RE: Bike Parking on Maine Medical Center's Bramhall
Campus

The purpose of this memo is to respond to the City of Portland's request to document quantity and location of existing bike parking on Maine Medical Center's Bramhall Campus. This request was made in the City Planning Department's Memo to the Planning Board dated 2/23/18 attachment 12.

Figure 1 – MMC Bramhall Campus Bike Parking Locations

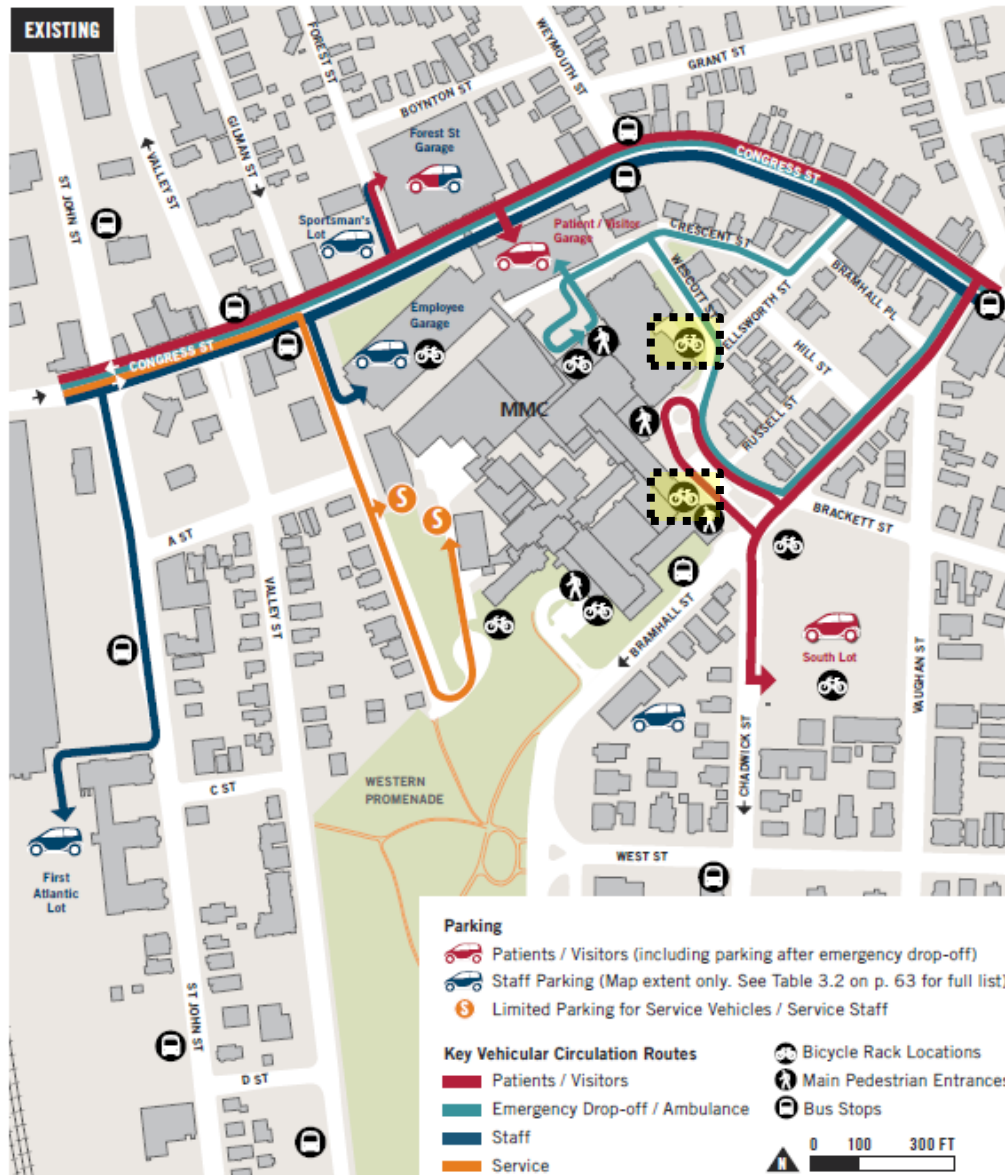
Figure 1 demonstrates that bike parking is “distributed to adequately serve all structure of main entrances.”

The two bike parking racks highlighted in Figure 1 nearest to the entrance of the East Tower meet the requirements of the City of Portland’s Technical Manual 1.15.
